DESCRIPTION:
Ltr notatized (not signed) 10-1-75.....
trans the following:
ACKNOWLEDGED
DO NOT REMOVE
PLANT NAME: Oconee 1, 2, & 3

ENCLOSURES:
Proposed Amdt to OL/Change to Tech Specs:
consisting of revised & addl pgs and info
concerning pressurization heatup & cooldown
limitations and to the reactor vessel material
surveillance program.....(40 cys encl rec'd)

Re: Oconee Nuclear Station
Docket Nos. 50-269, -270, -287

Pursuant to 10CFR50, §50.90, please find attached a proposed amendment to the Technical Specifications for Oconee Nuclear Station, Appendix A to Facility Operating Licenses DPR-38, -47 and -55. This proposed amendment incorporates changes to the pressurization, heatup and cool-down limitations, and to the reactor vessel material surveillance program. These changes are based on the report, "Analysis of Capsule OC1-F from Duke Power Company Oconee Unit 1 Reactor Vessel Materials Surveillance Program", BAW-1421 Rev. 1, September 1975.

Figure 3.1.2-1A

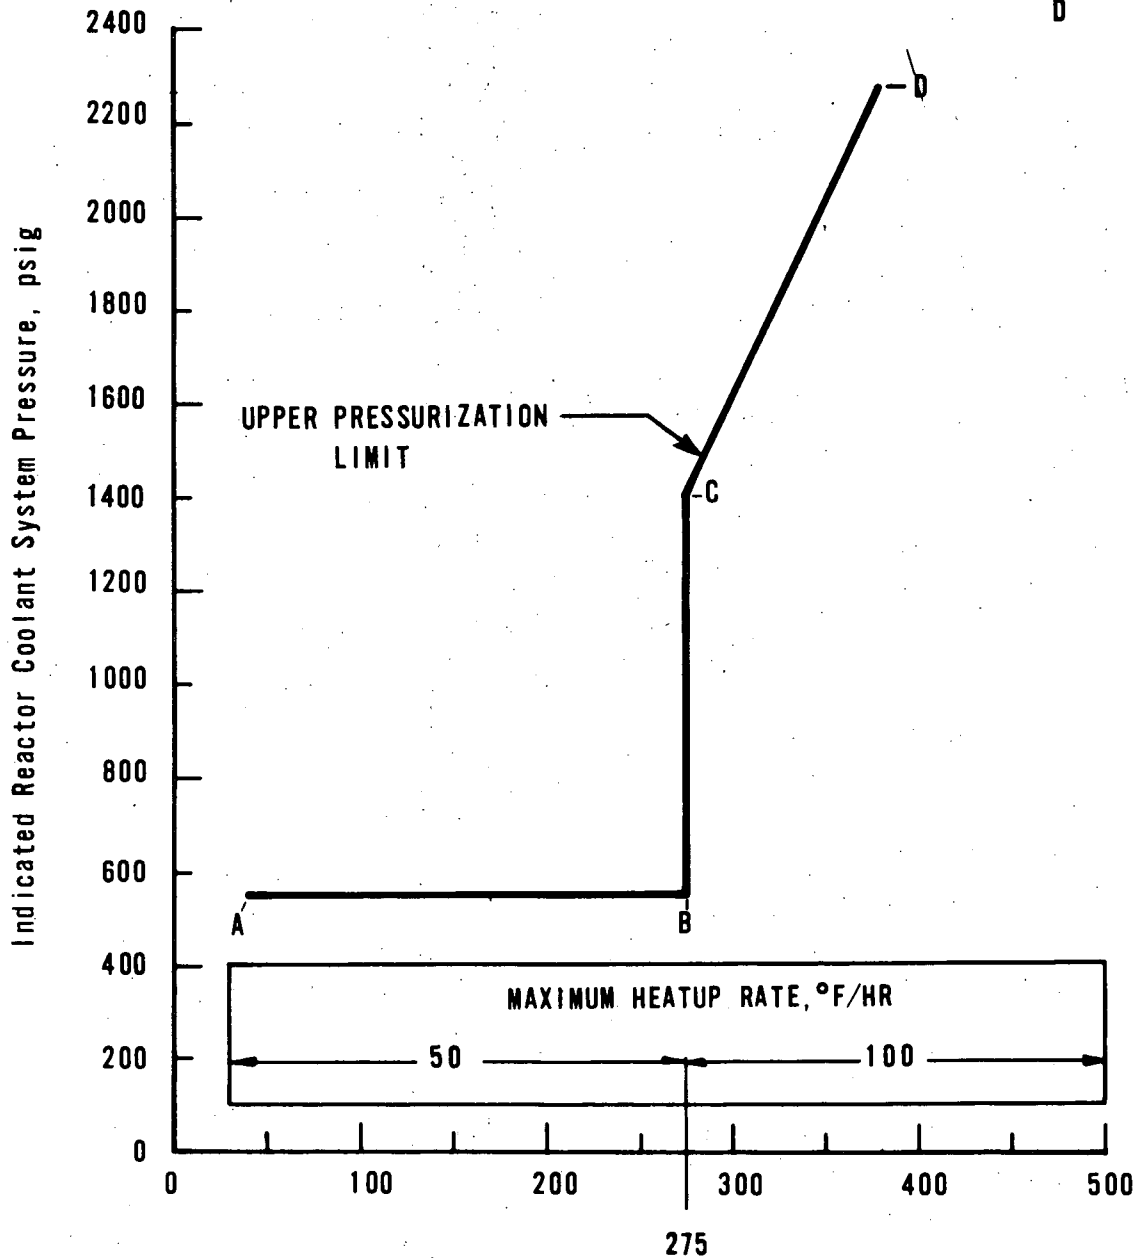
Heatup rates and allowable combinations of pressure and temperatures shall be limited in accordance with Figure 3.1.2-1A Unit 1
3.1.2-1B Units 2&3.

Figures 3.1.2-1A, 3.1.2-2A, and 3.1.2-3 present the pressure-temperature limit curves for normal heatup, normal cooldown and hydrostatic test respectively. The limit curves are applicable up to the fifth effective full power year of operation. These curves are adjusted by 25 psi and 10°F for possible errors in the pressure and temperature sensing instruments. The pressure limit is also adjusted for the pressure differential between the point of system pressure measurement and the limiting component for all operating reactor coolant pump combinations.

The pressure-temperature limit lines shown on Figure 3.1.2-1A for reactor criticality and on Figure 3.1.2-3 for hydrostatic testing have been provided to assure compliance with the minimum temperature requirements of Appendix G to 10CFR50 for reactor criticality and for inservice hydrostatic testing.

POINT	TEMP.	PRESS.
A	40	550
B	275	550
C	275	1400
D	380	2275

Figure 3.1.2-2A

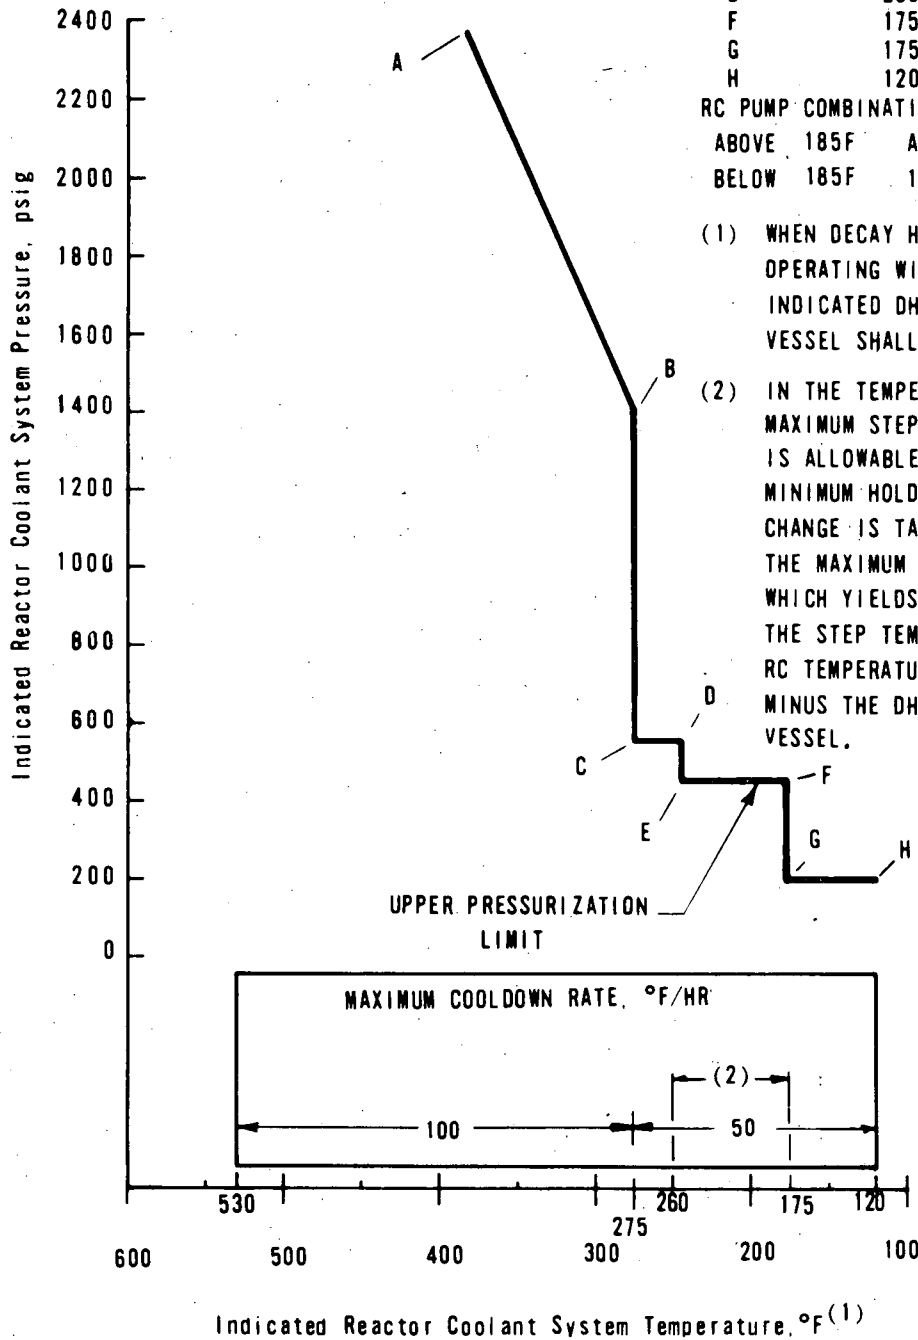
Cooldown rates and allowable combinations of pressure and temperature shall be limited in accordance with Figure 3.1.2-2A Unit 1
3.1.2-2B Units 2&3.

POINT	TEMP	PRESS
A	380	2275
B	275	1400
C	275	550
D	250	550
E	250	450
F	175	450
G	175	200
H	120	200

- (1) WHEN DECAY HEAT REMOVAL SYSTEM (DH) IS OPERATING WITHOUT ANY RC PUMPS OPERATING, INDICATED DH RETURN TEMP. TO THE REACTOR VESSEL SHALL BE USED.
- (2) IN THE TEMPERATURE RANGE 260F TO 175F, A MAXIMUM STEP TEMPERATURE CHANGE OF 75F IS ALLOWABLE FOLLOWED BY A ONE HOUR MINIMUM HOLD ON TEMPERATURE. IF THE STEP CHANGE IS TAKEN BELOW 250F RC TEMPERATURE, THE MAXIMUM ALLOWABLE STEP SHALL BE THAT WHICH YIELDS A FINAL TEMPERATURE OF 175F. THE STEP TEMPERATURE CHANGE IS DEFINED AS RC TEMPERATURE (BEFORE STOPPING ALL RC PUMPS) MINUS THE DH RETURN TEMPERATURE TO THE REACTOR VESSEL.

Figure 3.1.2-3

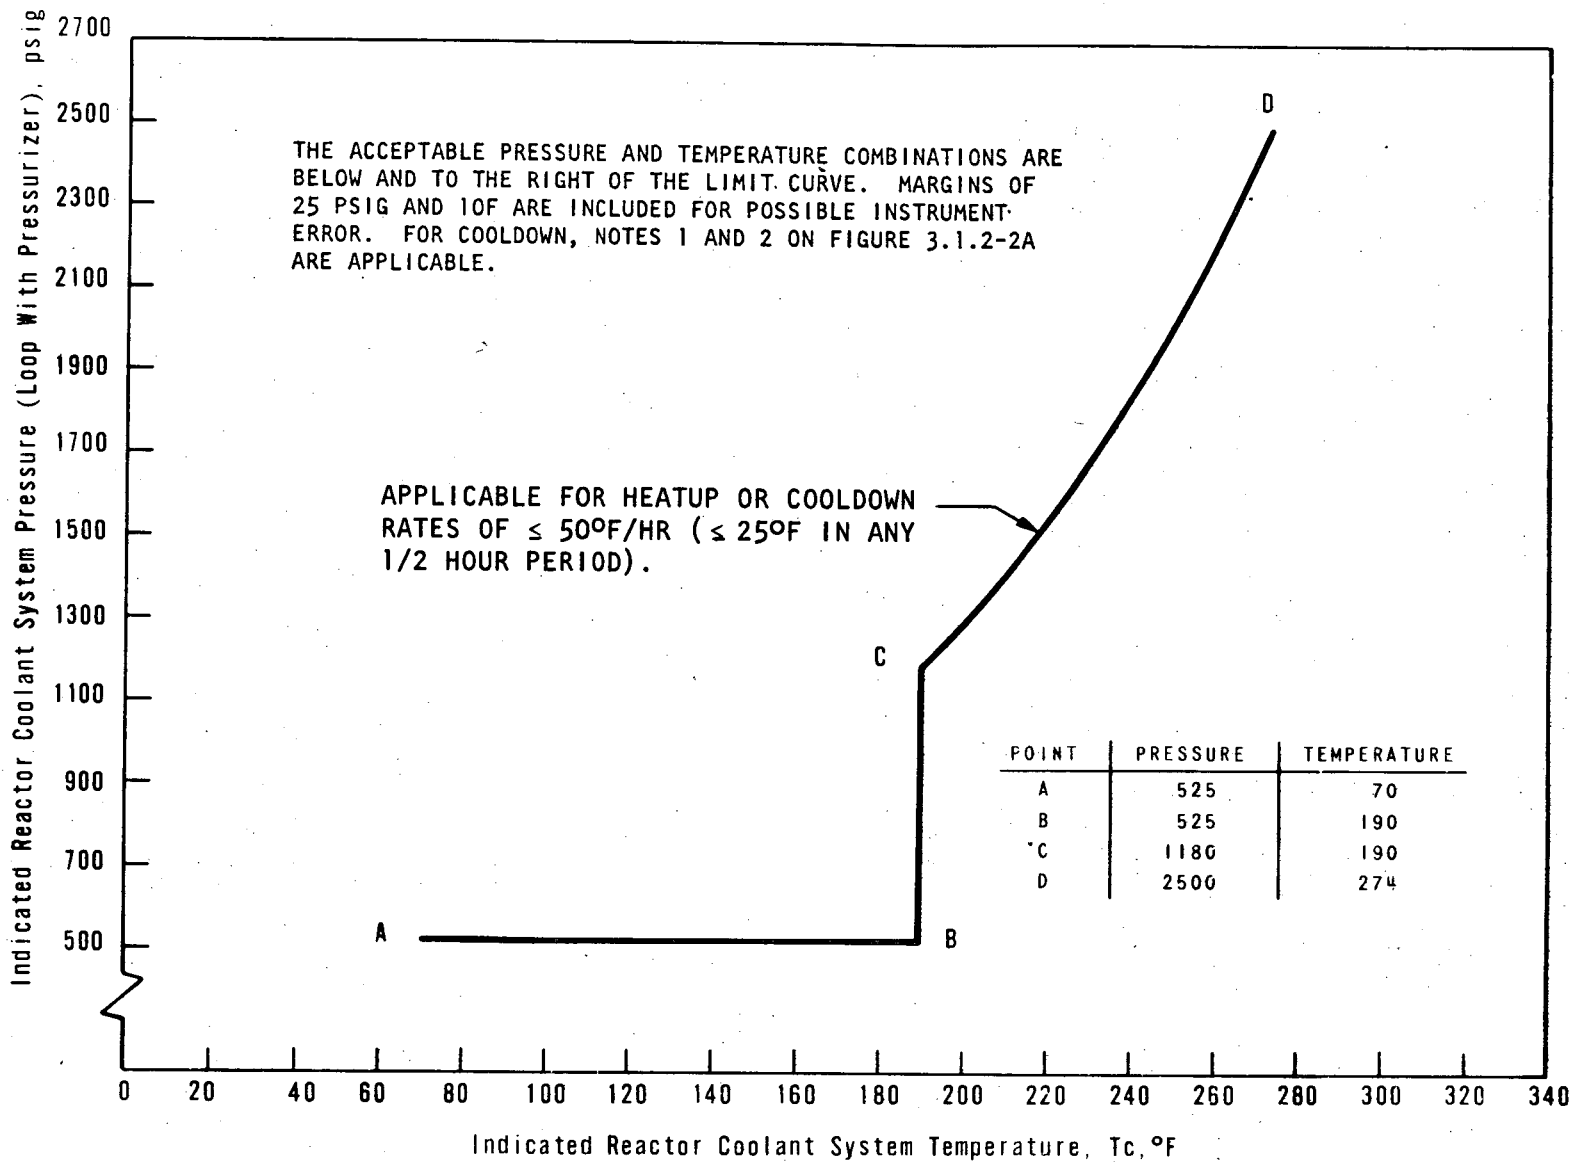
For thermal steady state system hydro test the system may be pressurized to the limits set forth in Specification 2.2 when there are fuel assemblies in the core under the provisions of 3.1.2.1 and to ASME Code Section III limits when no fuel assemblies are present provided the reactor coolant system is to the right of and below the limit line in Figure 3.1.2-3.
